產 品 變 更 通 知  
**PRODUCT CHANGE NOTIFICATION**

PCN No.	PCN-231001	Issue Date	Oct-04-2023
TITLE	SOT-23-5產品交期延長 SOT-23-5 Product Delivery Extension		Page 1 of 4

SOT-23-5產品交期延長  
SOT-23-5 Product Delivery Extension

SOT-23-5		SOT-25

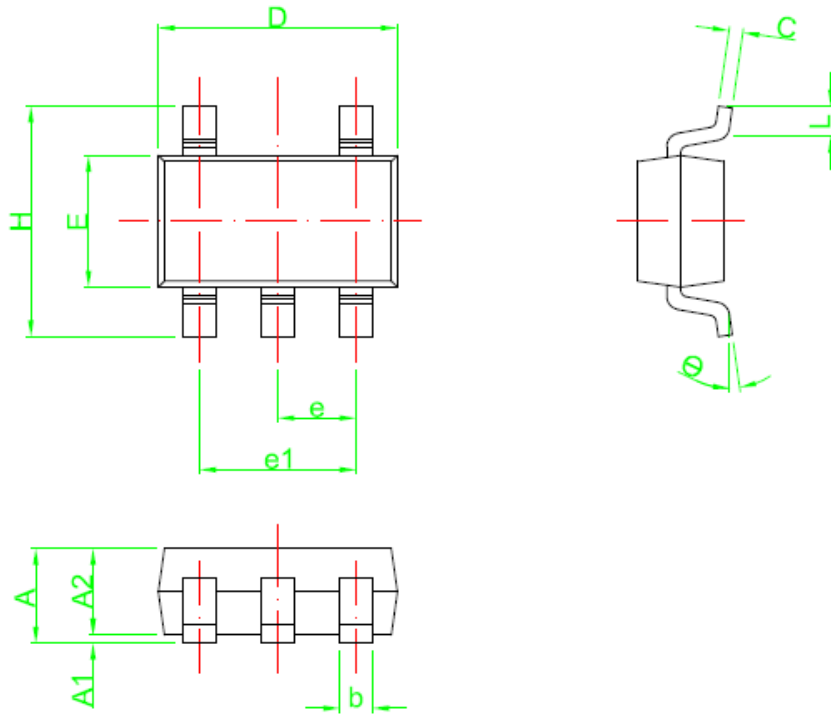
框架、外觀差異：

L/F、Appearance Differences

建議改出SOT-25封裝

Suggest changing to SOT-25 packaging
